Re: Case No. 2021-00029

Review and Evaluation of Martin County Solar Project, LLC Siting Assessment Report

**Review and Evaluation of
Martin County Solar Project, LLC
Siting Assessment Report**

Figure C-1.
Site Layout Map for Martin County Solar Project

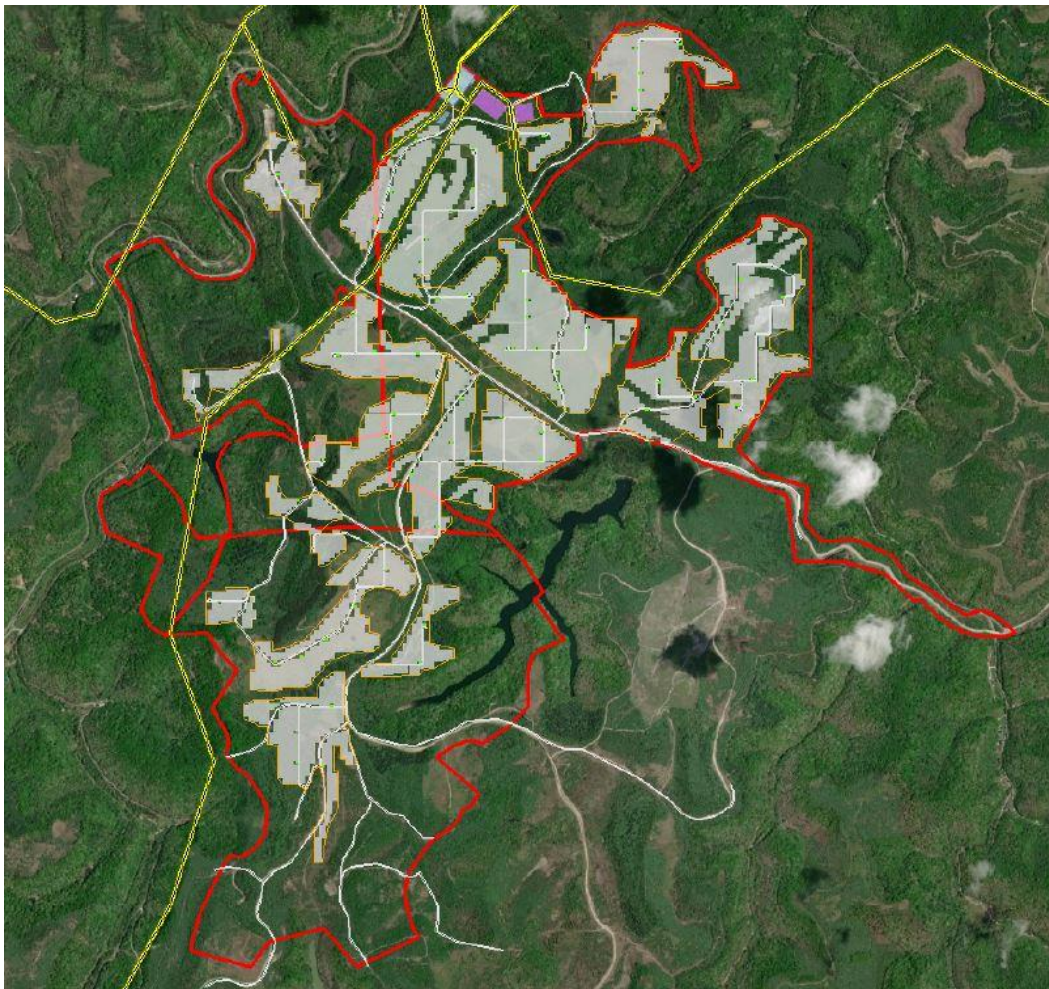
Access control. Page 4 of the SAR states that proposed access points are shown in SAR Exhibit A (Site Layout Map, shown in part in Figure C-1 of this report). However, while Exhibit A does depict the site boundary, fence line, and internal access roads, the actual entrances to site are not featured, and it is not clear how many entrances the proposed project would have or in what ways access through site entrances would be secured. BBC requested this information from the applicant in the RFI.

Location of buildings, transmission lines, and other structures. Exhibit A of the SAR (Site Layout Map, shown in part in Figure C-1 of this report), shows the proposed locations of the project's substation, two BESS units, inverters, solar arrays, and fencing, as well as the current locations of the existing transmission lines already on site. The locations of other proposed structures—such as the O&M trailer and the meteorological towers as described on page 2 of the SAR—is not clear. BBC requested information on the location of the O&M trailer from the applicant during the RFI process.

Location and use of access ways, internal roads, and railways. Internal roads are depicted in Exhibit A of the SAR (Site Layout Map). However, site entrances and access points are not shown, and BBC followed up with the applicant during the RFI to request this information. There is one railway adjacent to the proposed site and the applicant references it in the SAR by stating:

Figure C-4.
Site Access Points

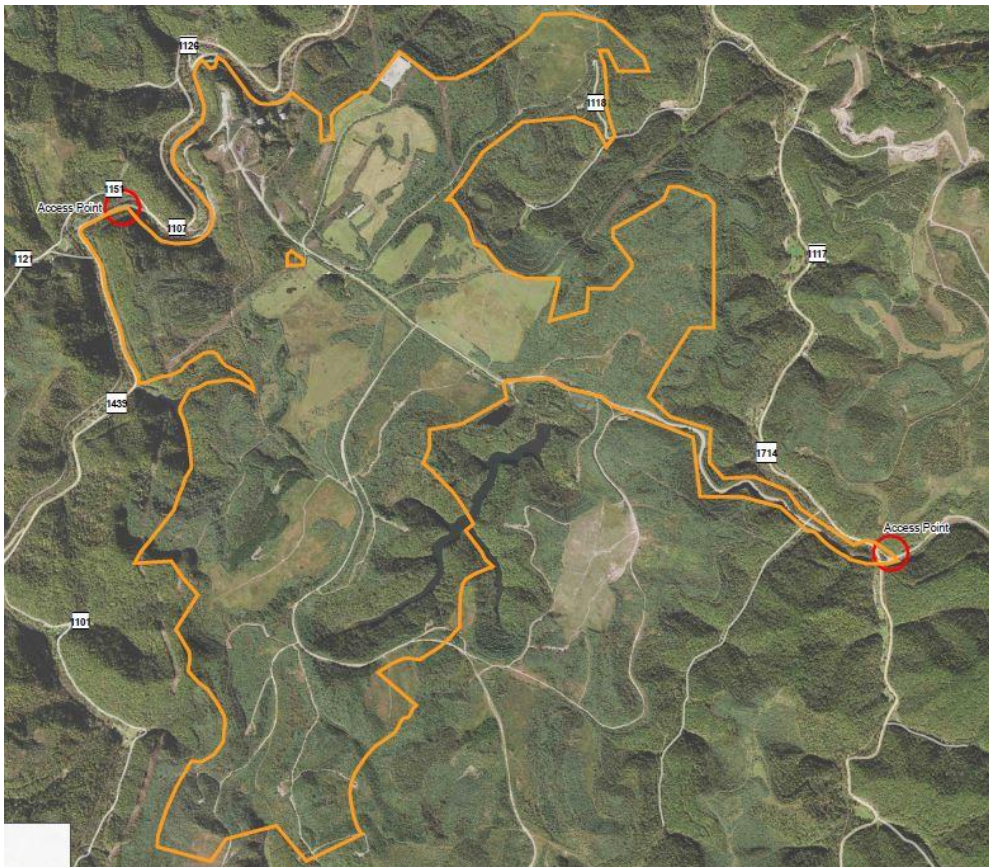
Access points to site. In their response to the first RFI, Martin County Solar provided a map detailing the location of the project's access entrances, which are both in place from the site's previous mining operation. The two access points are marked in red in the excerpted map in Figure C-4.
